# Work Order ID 91778

Item Name: Crosstube Turning Detail

<b>DART AEROSPACE LTD</b>	<b>Work Order:</b>	<b>91778</b>
<b>Description: Crosstube Assembly (412 High Aft)</b>	<b>Part Number:</b>	<b>D412-664-243</b>
<b>Inspection Dwg: D412-664-243 Rev: E</b>		<b>Page 1 of 2</b>

DRAWING NO. D412-664-243	TITLE CROSSTUBE ASSEMBLY (412 HI AFT)	REV. E	DART AEROSPACE LTD ENGINEERING ORDER		D.E.O. NO. D412-664-243-E-1	SHEET NO. SHEET 1 OF 2	SCALE NTS
DRAWN	CHECKED <i>MP</i>	MFG. APPR. <i>E</i>	APPROVED <i>MP</i>		DE APPR. <i>MP</i>		
DATE 11.03.31	DATE 11/03/31	DATE 11.03.31	DATE 11/03/31		DATE 11-03-31

**D412-664-243  
ASSEMBLY DETAIL**

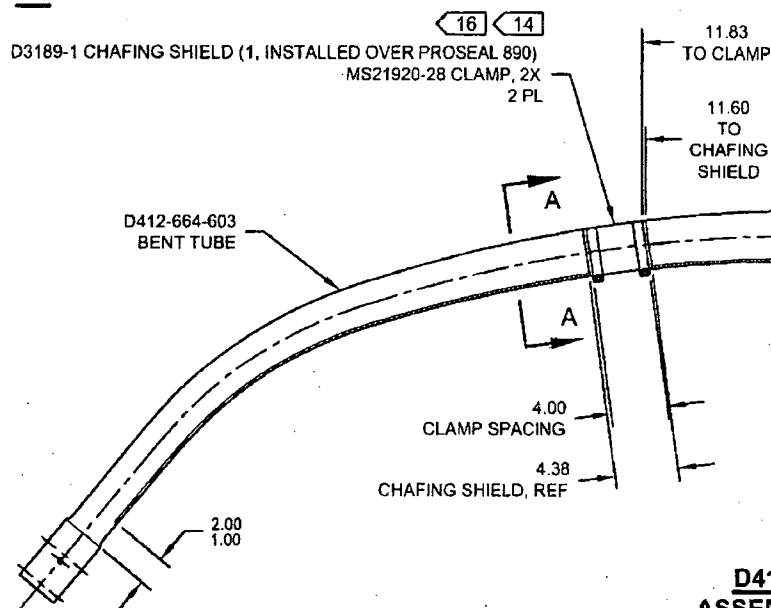
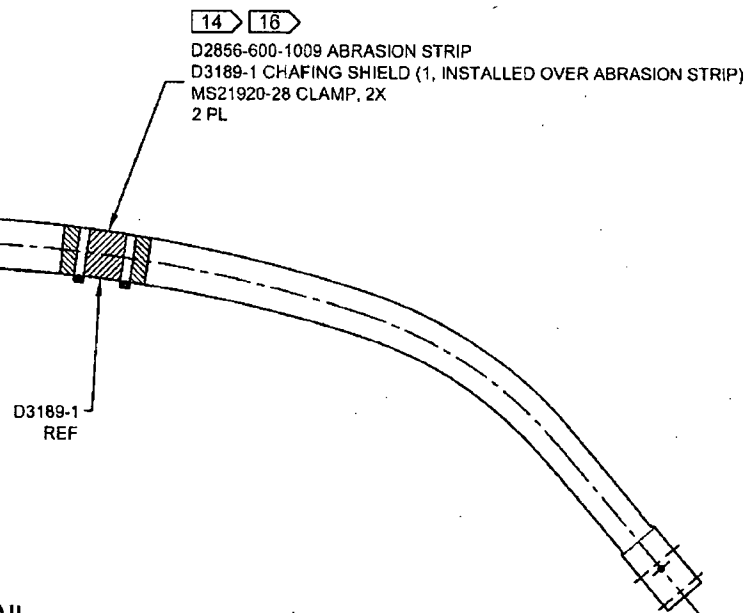
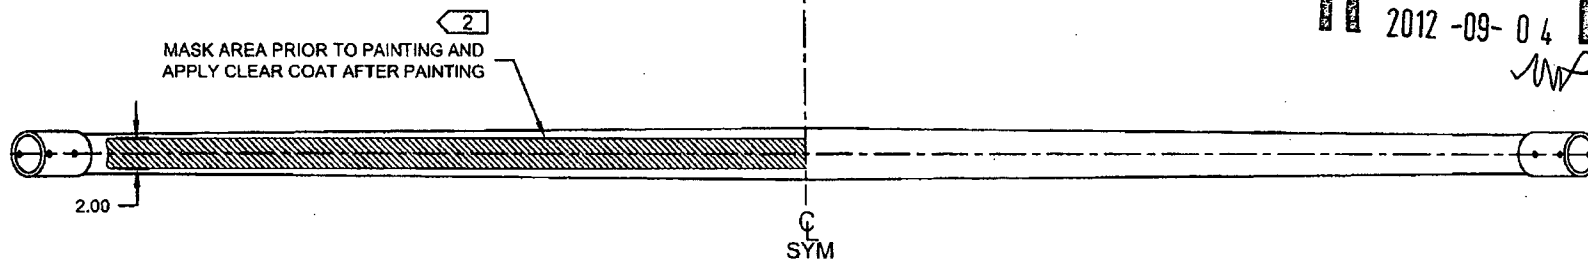
**PURPOSE:**

REMOVED ABRASION STRIP IN FAVOR OF A THIN LAYER OF PROSEAL 890. UPDATE INSTALLATION OF CHAFING SHIELDS AND REDUCE TORQUE TO 40-50 IN-LBS. THIS ENGINEERING ORDER SUPERCEDES DEO D412-664-243-E-1.

**IS:**

**WAS:**
